We have read your comments carefully and have made revision. We have tried our best to revise our manuscript according to the comments: "Application of Wave-current coupled Sediment Transport Models with Variable Grain Properties for Coastal Morphodynamics: A Case Study of the Changhua River, Hainan (egusphere-2024-2154)".

Figure 11 Flow field inside the estuary :(a) moment of the maximum flood current; (b) moment of the maximum ebb current

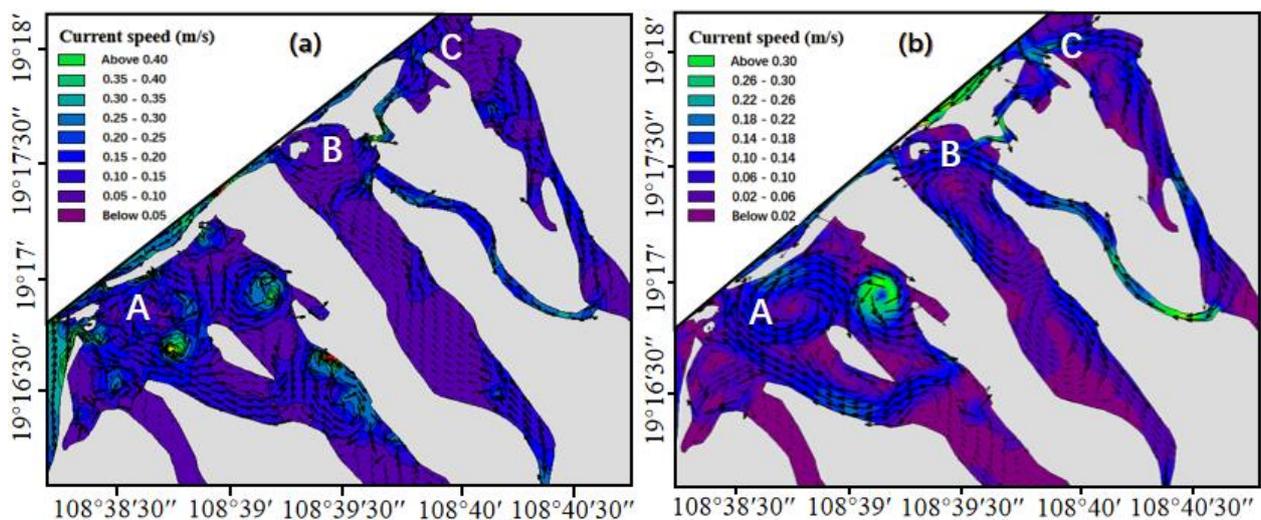
**Point 20: Section 3.3 lacks analysis of the hydrodynamic results, and the description of the hydrodynamic environment of the study area is insufficient. It is recommended to expand the text and analyze it in conjunction with the sediment transport model.**

Figures 11a and 11b illustrate the flow field inside the estuary of the Changhua River. Figure 11a shows the flow field at 23:00 on April 23, 2023, corresponding to the peak of the flood tide. Inside Estuary A, due to the topography, a large counterclockwise circulation forms around the central island, accompanied by several smaller vortices, with the overall trend of tidal currents flowing southeast along the river channel. In Estuary B, ocean inflows meet with river flows from upstream, ultimately converging into Estuary C through the passage between B and C. In Estuary C, the flow is more unidirectional compared to A and B, with upstream water flowing into the ocean, then following the northeast-directed tidal current outside the Changhua River estuary. Figure 11b shows the flow field at 13:30 on April 24, 2023, at the peak of the ebb tide. At this time, the circulation inside Estuary A reverses to a clockwise direction, and other smaller vortices change direction accordingly, with the overall trend of tidal currents flowing from upstream to the ocean. In Estuary B, the dominant force is the high-speed flow from Estuary C, which enters B through the narrow passage between B and C, splitting into two opposite directions: one part flows into the ocean, and the other flows upstream, forming a circulation within the river channel. In Estuary C, the water flows upstream from the ocean along the river channel.
